MFN 08-145

**Subject: Response to NRC Request for Additional Information Letter 131
Related to the ESBWR Design Certification – Radioactive Waste
Management Systems – RAI Numbers 11.2-16S01, 11.2-17
through 11.2-31, 11.3-4 through 11.3-12, 11.4-15S02, 11.4-19
through 11.4-32, and 11.5-48 through 11.5-53**

**Response to Portion of NRC Request for
Additional Information Letter No. 131**

Radioactive Waste Management Systems

Figure 11.2-1. Liquid Waste Management System Process Diagram

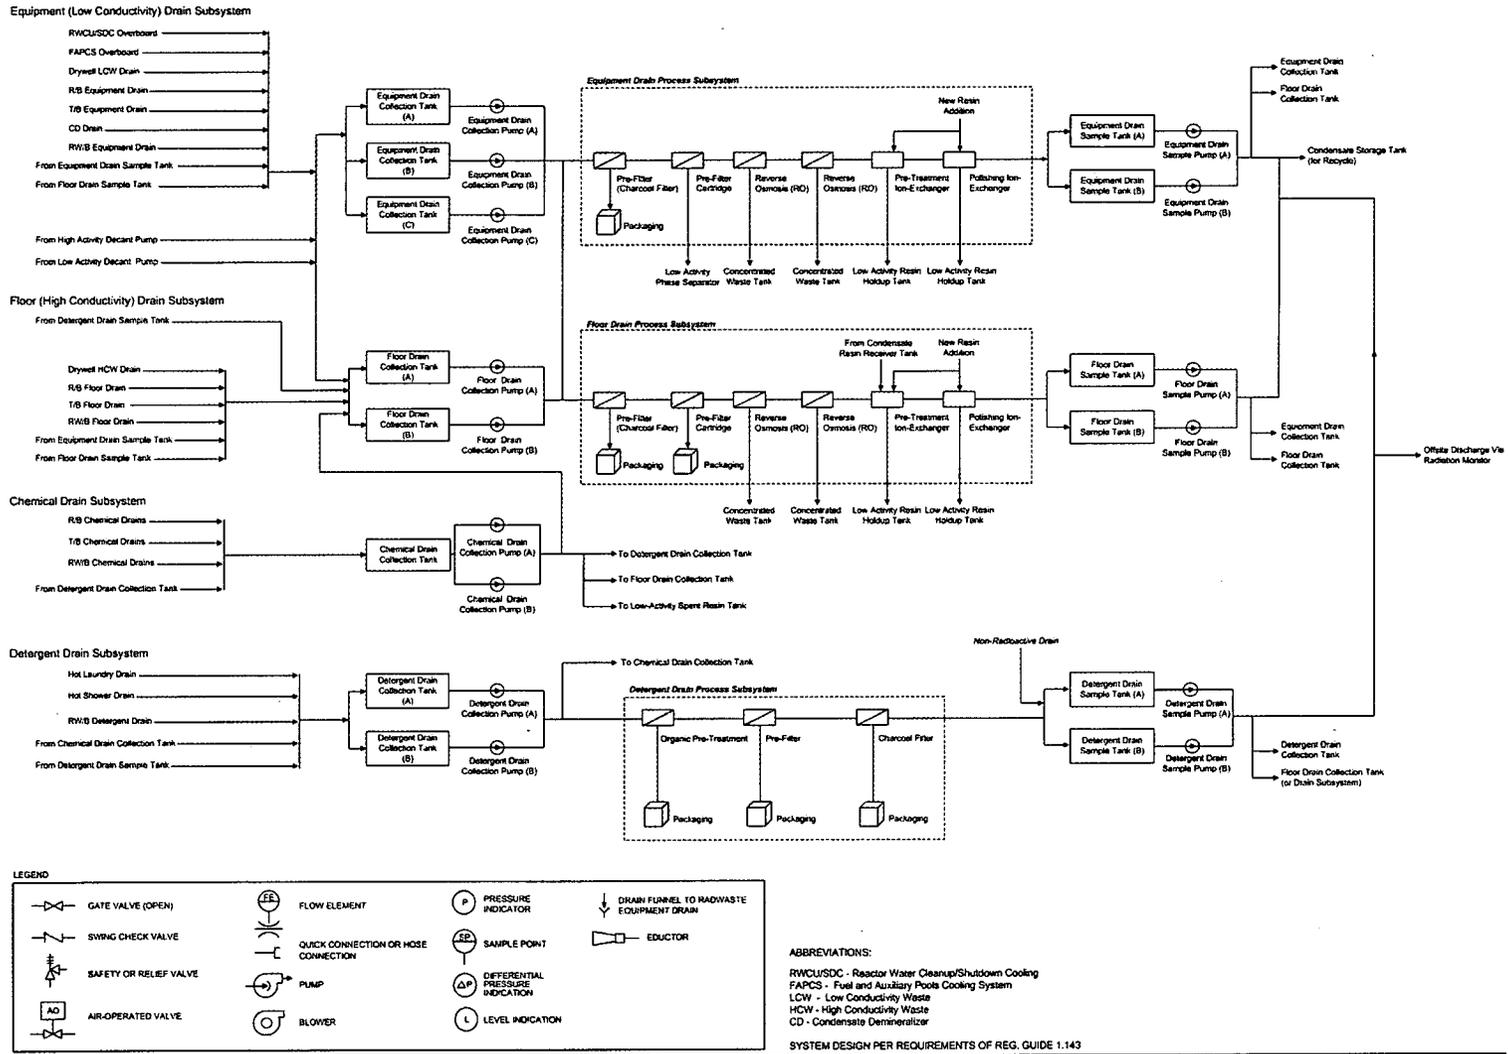
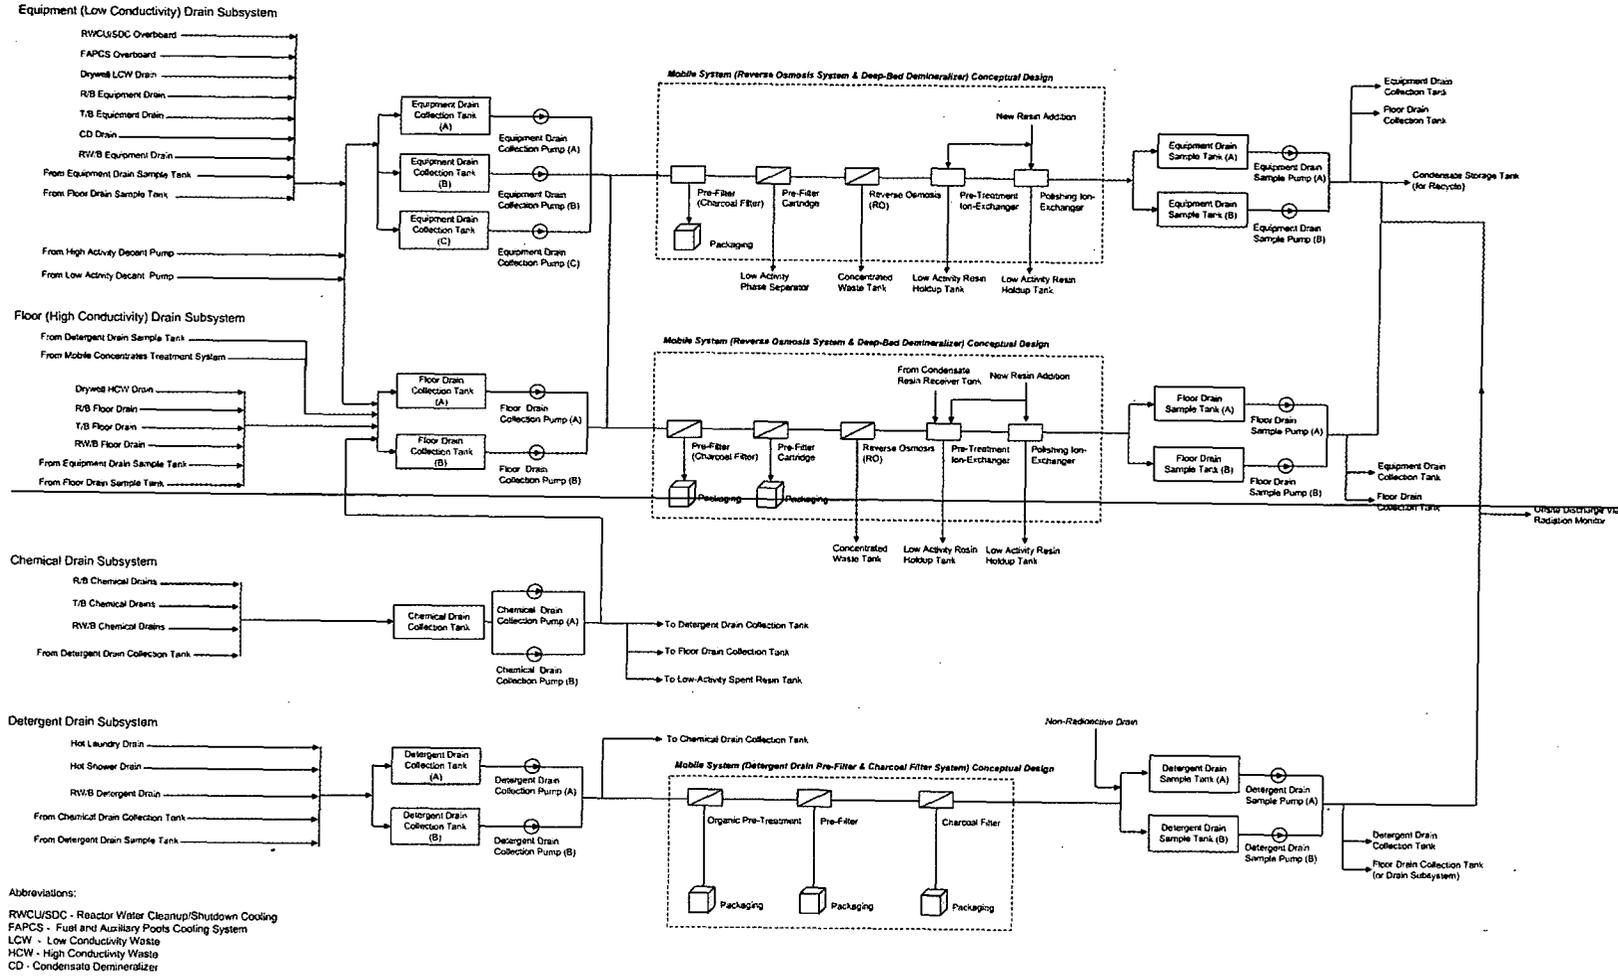
A comparison of DCD, Tier 2, Figure 11.2-1 against Figures 11.2-1a and 11.2-1b indicates an inconsistent number of reverse osmosis (RO) units.

Figure 11.2-1 shows one RO unit each for the Equipment Drain Subsystem and Floor Drain Subsystem, while Figures 11.2-1a and 11.2-1b show two RO units for each. Accordingly, revise DCD, Tier 2 figures to make the functional arrangements of these subsystems internally consistent in DCD, Section 11.2.

A review of DCD, Tier 2, Revision 4, Section 11.2, Figures 11.2-1 to 11.2-4 reveals that legends are missing in explaining the details of the piping drawing for the LWMS. Accordingly, revise DCD Tables 11.2-1 to 11.2-4 to include the appropriate sets of legends for the purpose of interpreting system functional operations.

GEH agrees and will revise DCD Figure 11.2-1 to show two reverse osmosis (RO) units.

DCD Tier 2, Figure 11.2-1 will be revised as noted on the attached markup.

DCD, Tier 2, Section 11.2, Figures 11.2-1 to 11.2-4 will be revised as noted on the attached markup.

Figure 11.2-1a. Equipment Drain

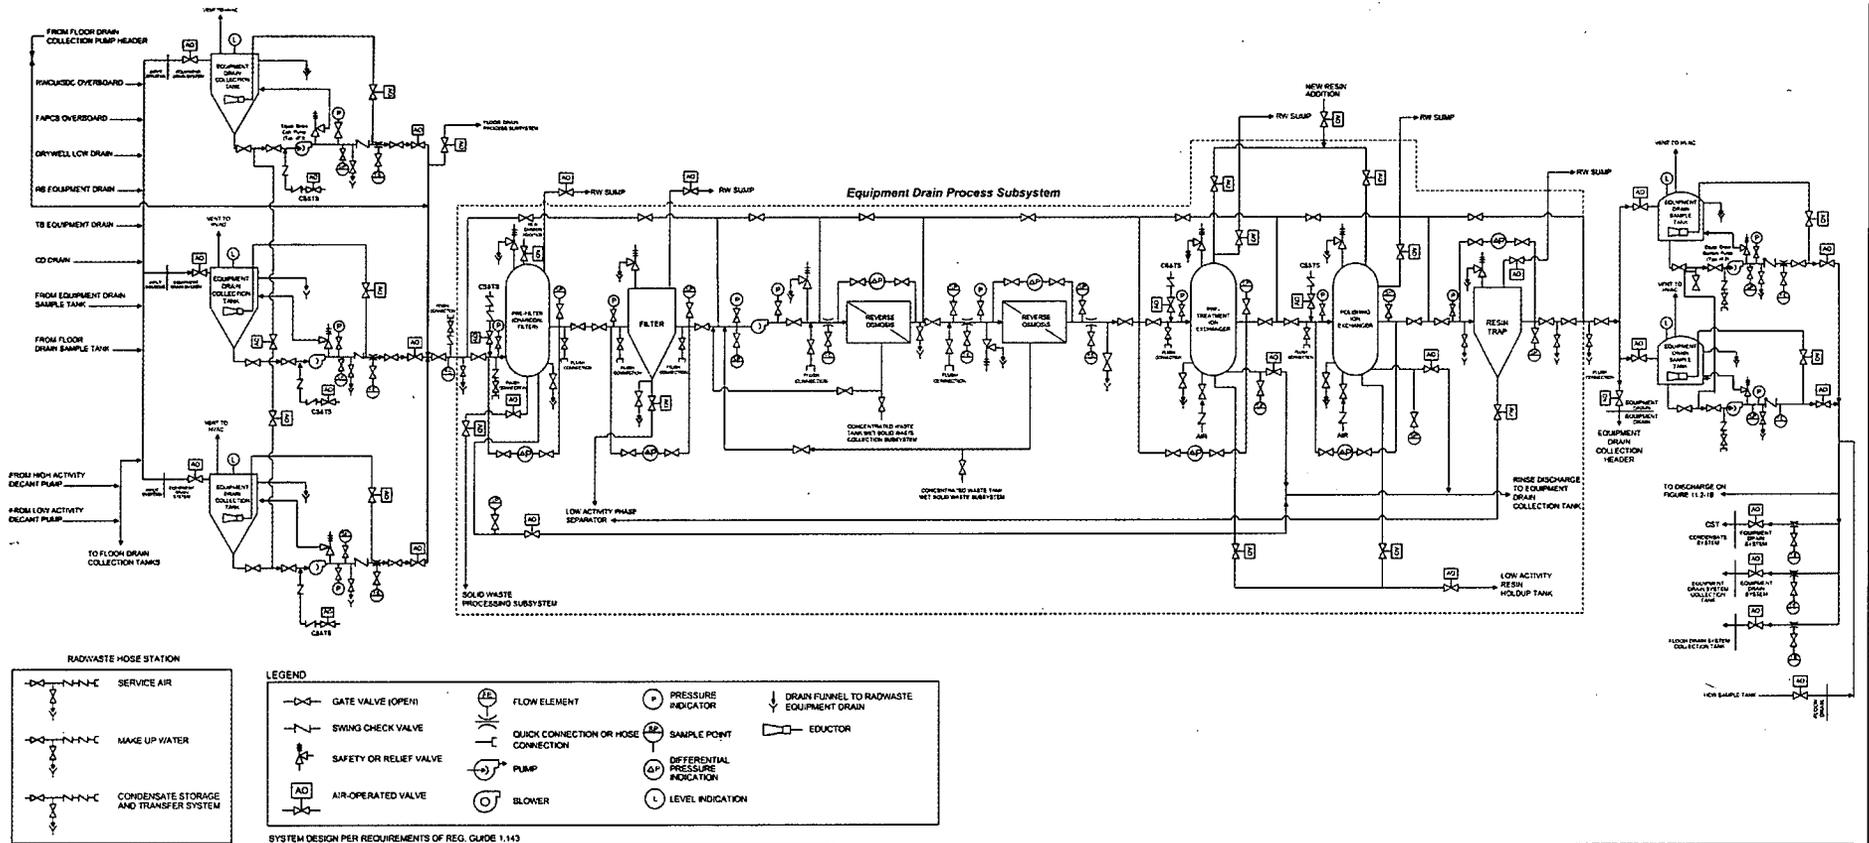
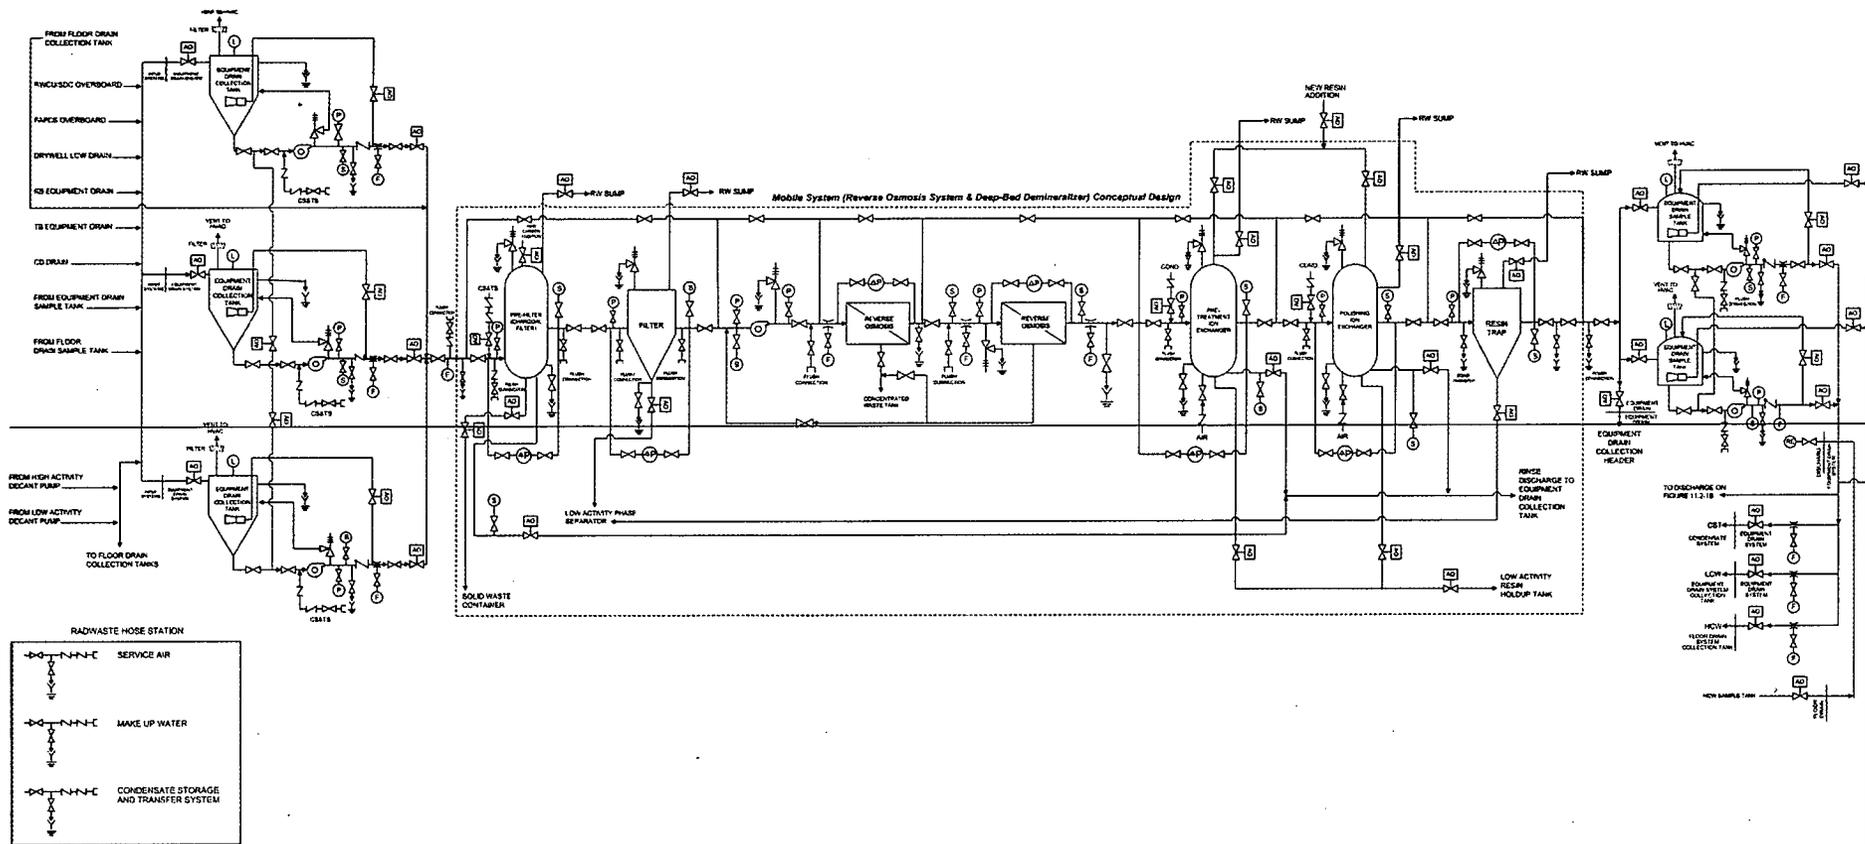
DCD, Tier 2, Figures 11.2-1a, 11.2-1b, 11.2-3, and 11.2-4 show overflows and drain funnels with no end dispositions. Revise the above listed figures to provide the disposition or endpoints of these overflows. If it is to a tank/sump, then include sump/tank size, pump flow rate capability, and where the sump/tank will flow or be pumped to, such as which subsystem components. Address the above issues and update DCD, Tier 2, Section 11.2 tables and text accordingly.

GEH agrees with the staff's findings that DCD, Tier 2, Figures 11.2-1a, 11.2-1b, 11.2-3, and 11.2-4 show overflows and drain funnels with no end dispositions. DCD, Tier 2, Figures 11.2-1a, 11.2-1b, 11.2-3, and 11.2-4 will be revised adding drain funnels showing destinations to floor and equipment drains. The power generation design basis of floor and equipment drains is described DCD, Tier 2, Section 9.3.3.1 that states: "Drainage systems are designed to accommodate the maximum anticipated normal volumes of liquid without overflowing including such inputs as the anticipated water flow from a fire hose and other fire suppression water discharges to the area floor drains without impacting the safety function of any safety-related component or system. However, as delineated in Subsection 3.4.1.3, no credit is taken for the drainage system in the flooding analysis." Sump/tank size, pump flow rate capability, and where the sump/tank will flow or be pumped to, such as which subsystem components, will not be added to DCD, Tier 2, Section 11.

DCD, Tier 2, Figures 11.2-1a, 11.2-1b, 11.2-3, and 11.2-4, will be revised as noted on the attached markup.

Figure 11.2-4. Chemical Drain

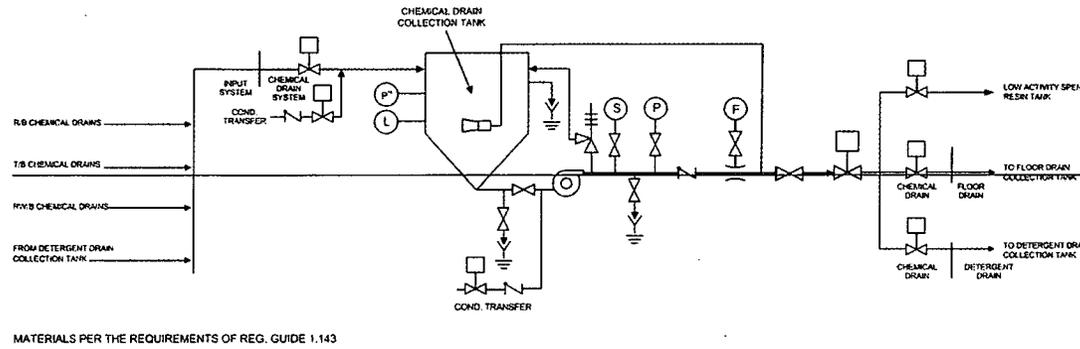
A review of DCD, Tier 2, Figure 11.2-4 shows that the Chemical Drain Collection Tank is not equipped with a vent. Accordingly, justify the omission of a vent for this tank or update DCD, Tier 2, Figure 11.2-4 to include a vent in its design.

DCD, Tier 2, Revision 4, Section 11.2, Table 11.2-2b and Figure 11.2-4 show an inconsistent number of pumps. DCD Table 11.2-2b lists two (2 pumps for the chemical drain system but Figure 11.2-4 shows only one. Accordingly, update the table and figure for consistency in listing the number of pumps.

GEH concurs with the staff finding and will update DCD, Tier 2, Figure 11.2-4 to include a vent in the design.

GEH concurs with the staff finding and will update DCD, Tier 2, Revision 4, Section 11.2, Figure 11.2-4 to show 2 chemical drain pumps.

DCD, Tier 2, Section 11.2, Figure 11.2-4 will be revised as noted on the attached markup.

Figure 11.4-1. Solid Waste Management System Process Diagram

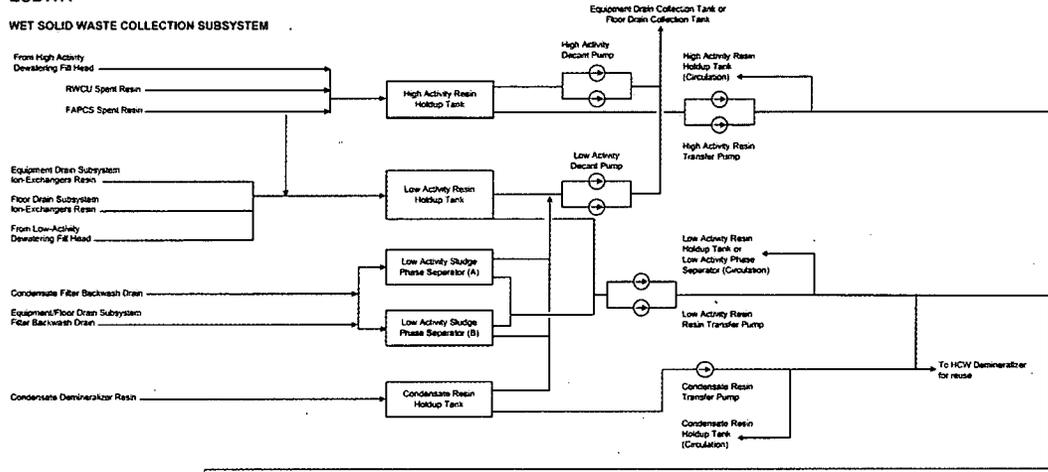
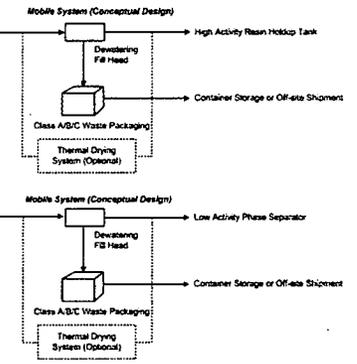
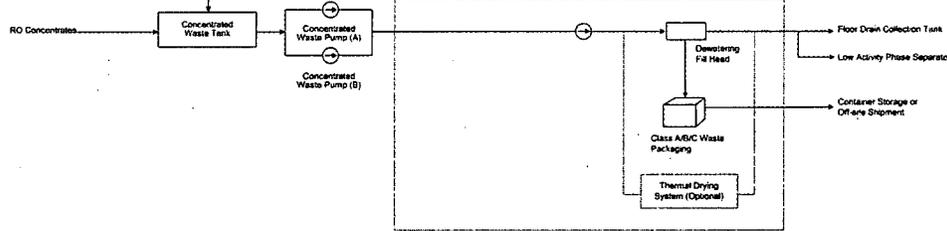
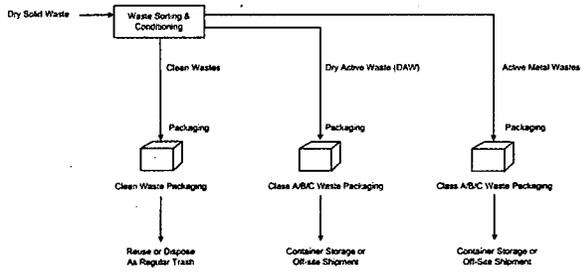
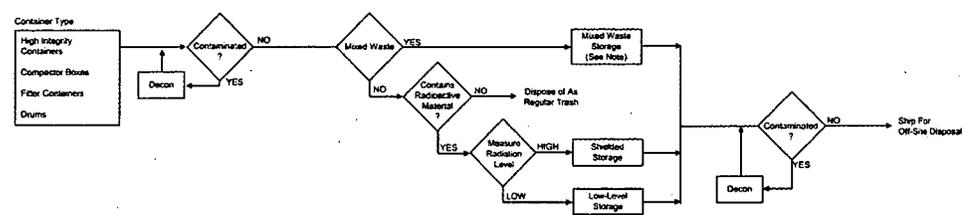
Throughout DCD, Tier 2, Chapter 11.4, the phase separators are referred to as "Low Activity Phase Separators", but Figure 11.4-1, Solid Waste Management System Process Diagram, refers to the phase separator as "Low Activity Sludge Phase Separators." Address this inconsistency in terminology and revise DCD, Tier 2, Section 11.4 and associated figures accordingly.

GEH agrees with the inconsistency identified by the staff. DCD, Tier 2, Chapter 11.4, Figure 11.4-1, Solid Waste Management System Process Diagram, wording will be revised to reflect "Low Activity Phase Separators."

DCD, Tier 2, Chapter 11.4, Figure 11.4-1 will be revised as noted on the attached markup.
